LUFTVÄRDIGHETSDIREKTIV (LVD)

A Motordrivna Luftfartyg Enstrom LVD Nr 2-3233 Upphäver 2-3184

TITEL: Kontroll av huvudrotoraxel.

2002-08-03 Enstrom Helicopter Corporation: Amendment 39-12710. Docket No. 2001-SW-67-AD. Supersedes AD 2001-22-01, Amendment 39-12479, Docket No. 2001-SW-28-AD.

Figure 1. Main Rotor Shaft Inspection

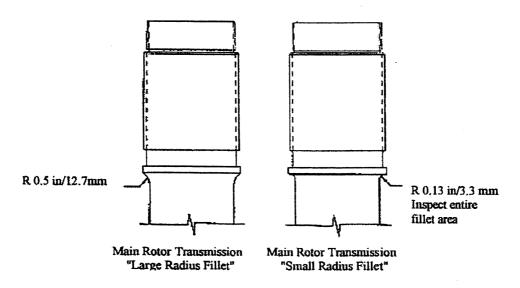
(a) Before further flight, determine the part number (P/N) of the main rotor transmission (transmission) and the radius of the upper fillet of the shaft (as shown in the following Figure 1):

- (b) For EHC Model F-28C, F-28F, 280C, 280F, and 280FX helicopters, before further flight, replace any transmission having a small radius shaft fillet with an airworthy transmission having a large radius shaft fillet as specified in Table 1 of this AD.
 - (c) For EHC Model F-28, F-28A and 280 helicopters:
- (1) If the transmission has a shaft with a small radius fillet and the transmission P/N is not listed in Table 1, before further flight, replace the transmission with an airworthy transmission specified in the following Table 1 of this AD:

- (2) If the installed transmission is P/N 28-13101-1 or -1-R, or P/N 28-13101-3 or -3-R, and has a small radius shaft, before further flight and thereafter at intervals not to exceed 25 hours TIS, visually inspect each transmission for a crack in the shaft upper fillet using a 10X or higher magnifying glass.
- (i) If there is any indication of a crack, before further flight, a level II nondestructive inspector must dye-penetrant inspect the shaft using materials approved by MIL-I-25135.
- (ii) If the shaft is cracked, before further flight, replace the transmission with an airworthy transmission having a large radius shaft fillet.

- (i) Dye-penetrant inspect the shaft upper fillet for a crack, a nick, or a scratch.
 - (ii) Polish out nicks or scratches less than 0.005-inch deep.
- (iii) If the shaft is cracked or has a nick or scratch 0.005 inch or more deep, replace the transmission with an airworthy transmission having a large radius shaft fillet before further flight.
